Arlington Zoning Board of Appeals

4. **Thorndike Place: Discussion of Architectural and Urban Design Aspects of Project Submission.**
5. **Thorndike Place - Updated Documents from Applicant**
6. **Thorndike Place - Public Comments**
7. **Thorndike Place - Previous Correspondence Received**
8. **Thorndike Place - New Documents**

Type	File Name	Description
▢ Reference Material	2021-01-18_Stormwater_Report.pdf	2021-01-18 Stormwater Report
▢ Reference Material	2021-01-22_Response_to_Stormwater_Peer_Review-Thorndike_Place.pdf	2021-01-22 Response to Stormwater Peer Review-Thorndike Place
▢ Reference Material	FIA_Thorndike_Place_(00186746xBC4F6).pdf	FIA_Thorndike Place (00186746xBC4F6)
▢ Reference Material	2021-01-21_Revised_Plan_Sheets.pdf	2021-01-21 Revised Plan Sheets
▢ Reference Material	2021-01-25_Response_to_BETA_Traffic-Thorndike_Place_with_Attachment.pdf	2021-01-25 Response to BETA Traffic-Thorndike Place with Attachment
▢ Reference Material	Thorndike_Place_Revised_Wetland_Delineation_Memo_2021-01-18_with_Field_Data_Forms.pdf	Thorndike Place Revised Wetland Delineation Memo_2021-01-18 with Field Data Forms

ISSUED FOR PERMITTING
NOT FOR CONSTRUCTION

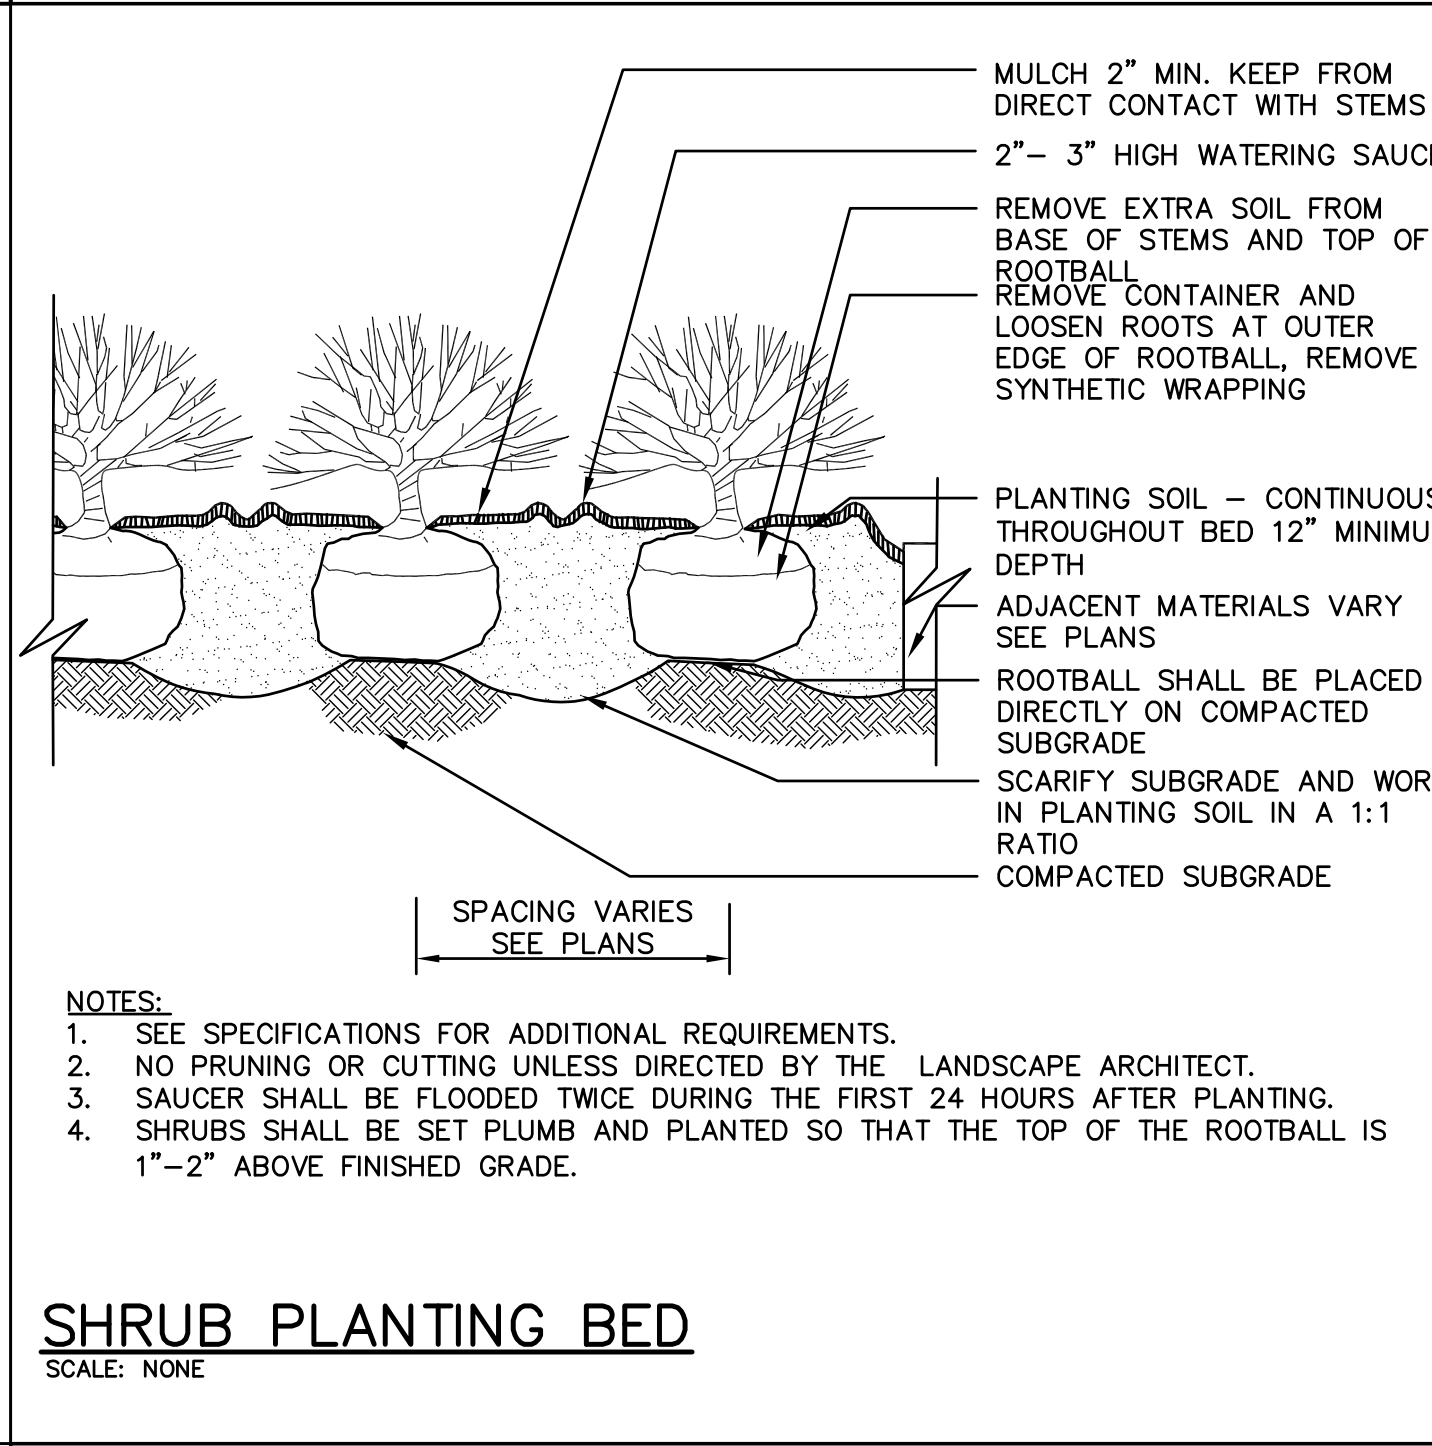
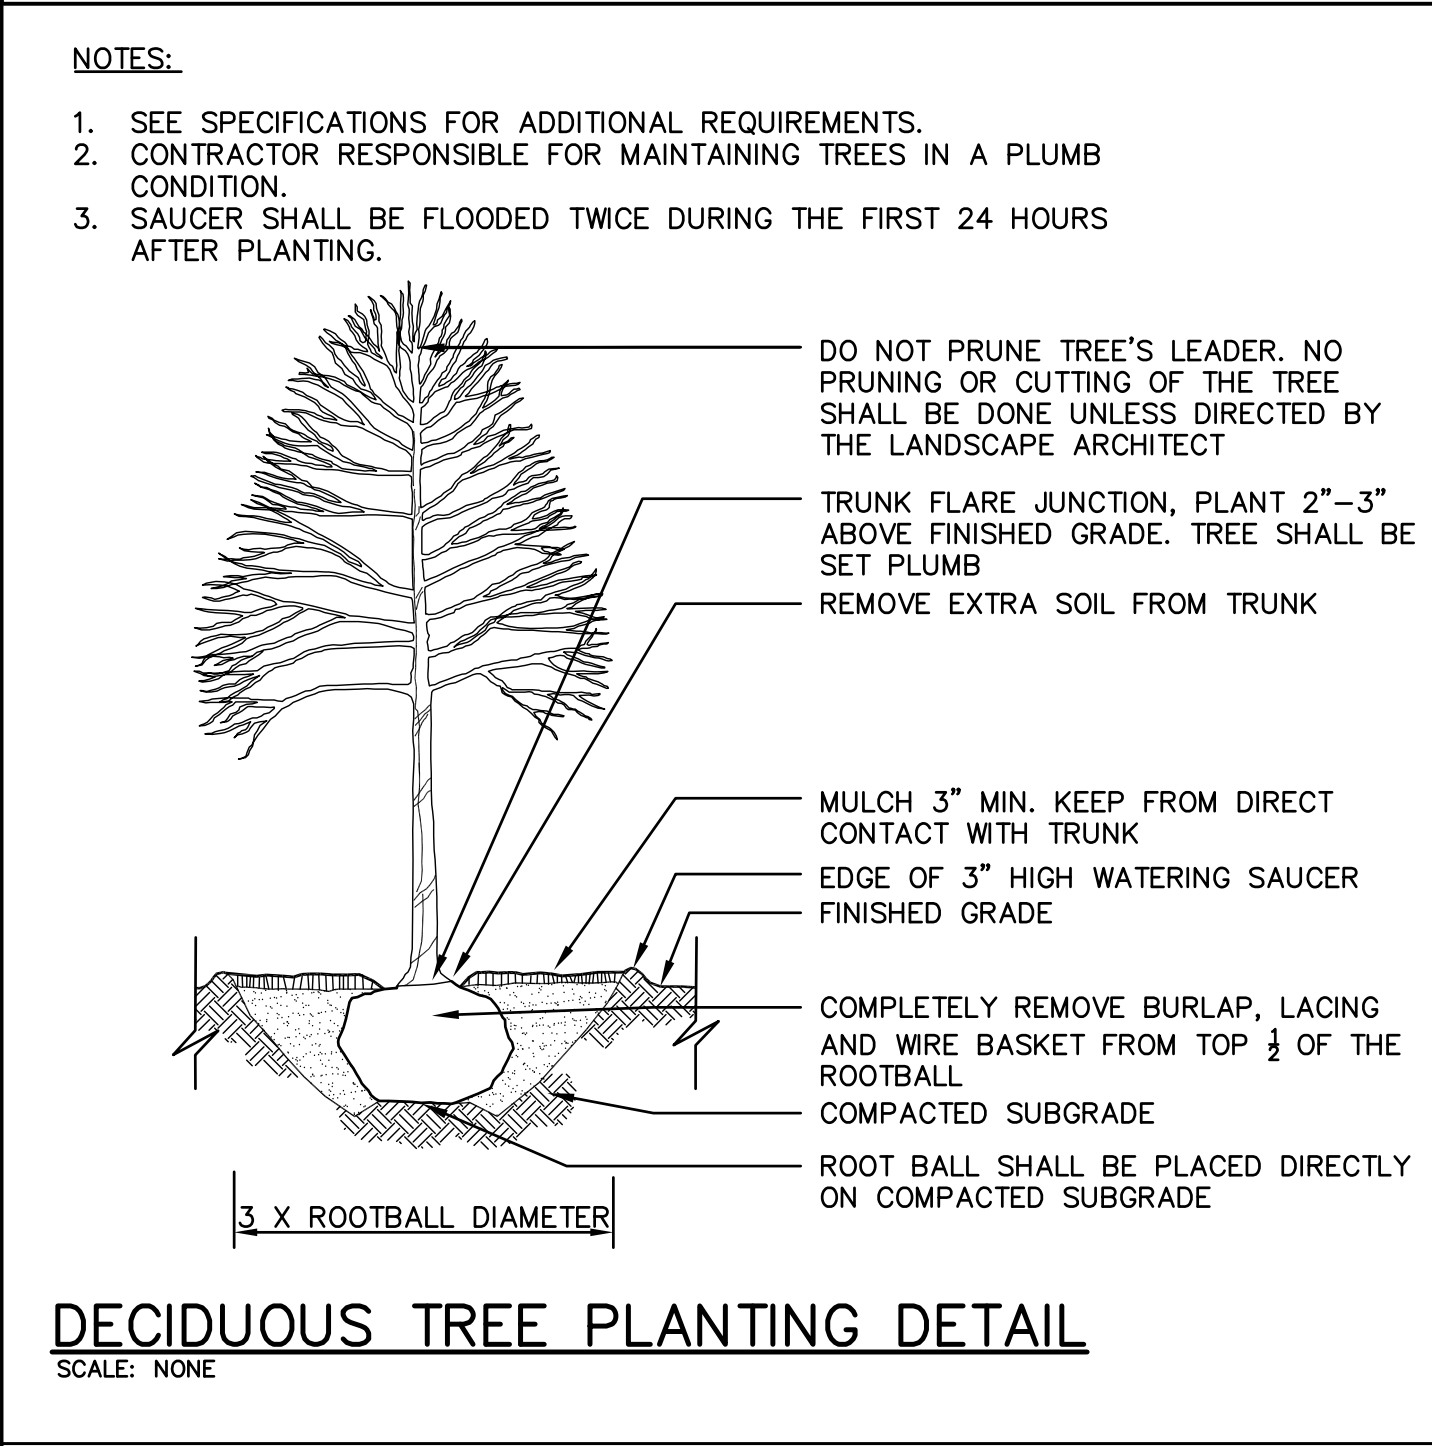
9. Civil and Landscape Details (sheet 1) – The applicant has provided a Silt fence with Haybales erosion control barrier detail.

Response: The perimeter erosion controls have been revised as recommended and are shown on the enclosed revised Site Preparation Plan and Grading & Drainage Plan. A detail of the 18-inch diameter compost-filled silt sock with silt fence has been added to the enclosed Civil and Landscape Details (Sheet C-200).

Figure 2R
Existing Intersection Lane Use,
Travel Lane Width, and
Pedestrian Facilities

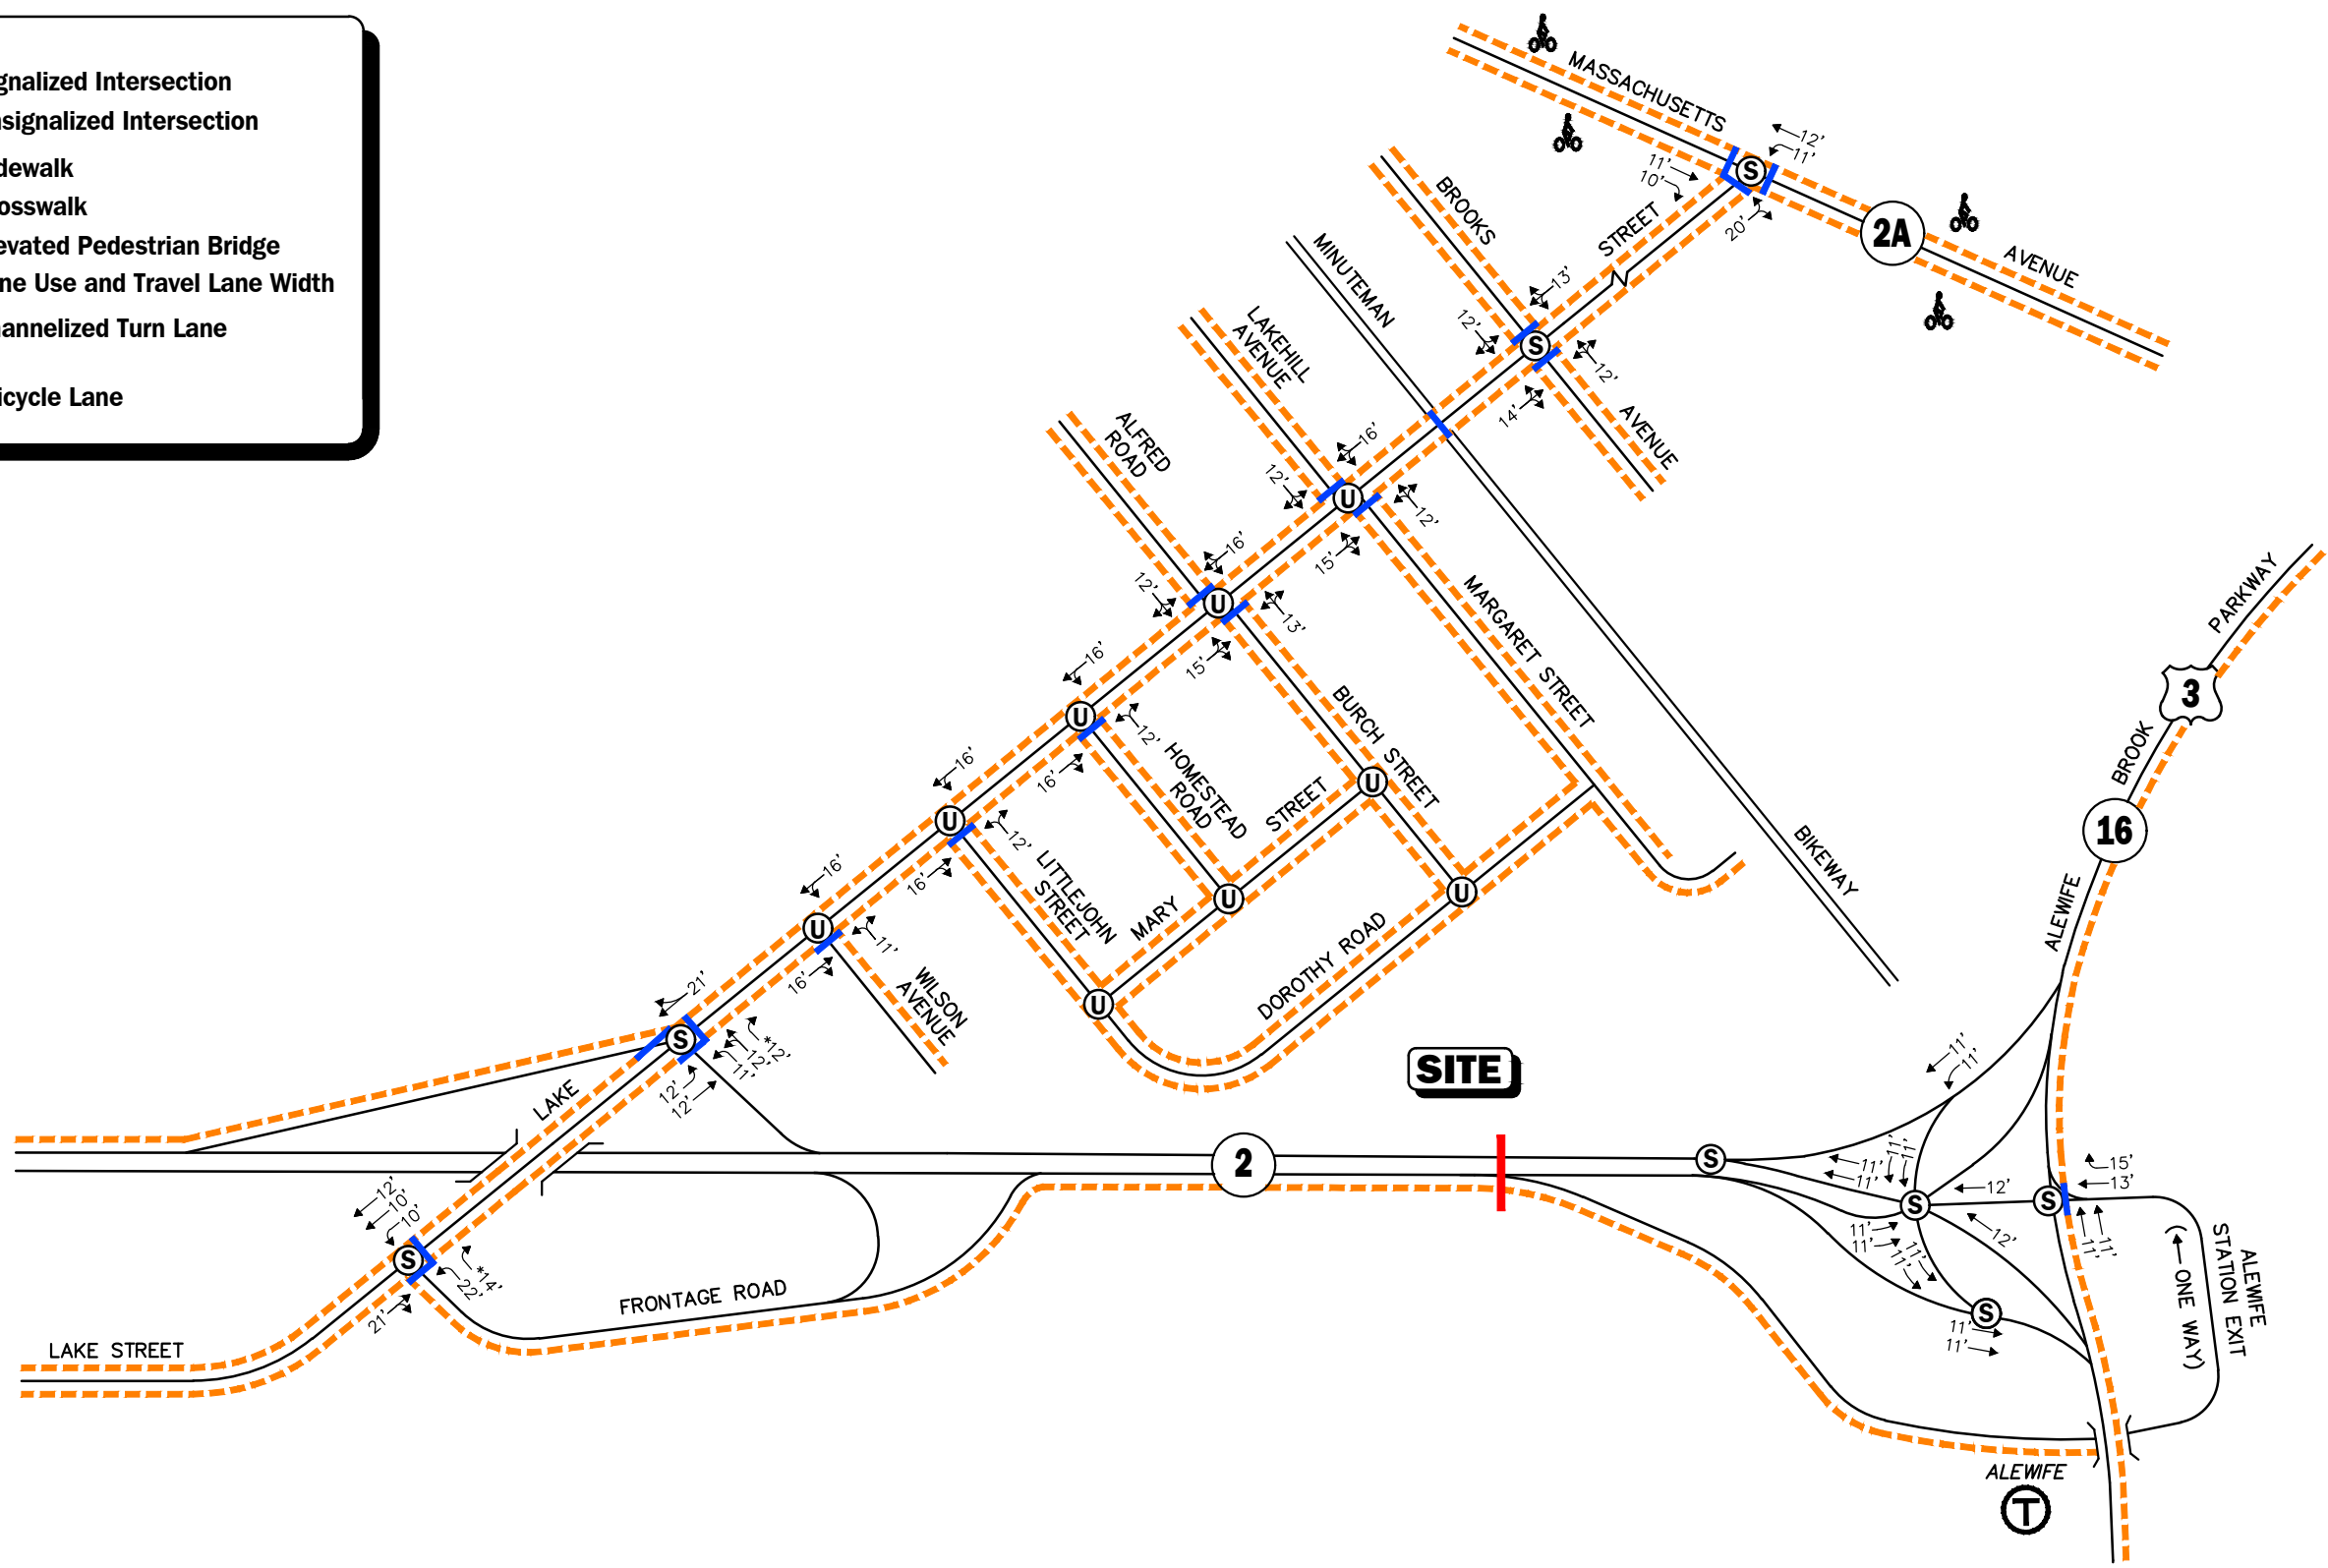
Comment No. 10: *“Figure 2 and all subsequent volume diagrams show the Alewife Station Access Road as one-way southbound, though lane uses are shown traveling northbound. Revise orientation of the one-way arrow.”*

Response: Figures 2 through 11 have been revised to show the correct one-way northbound orientation of Alewife Station Access Road. These revisions are depicted on Figures 2R through 11R, which can be found in the Appendix of this letter.
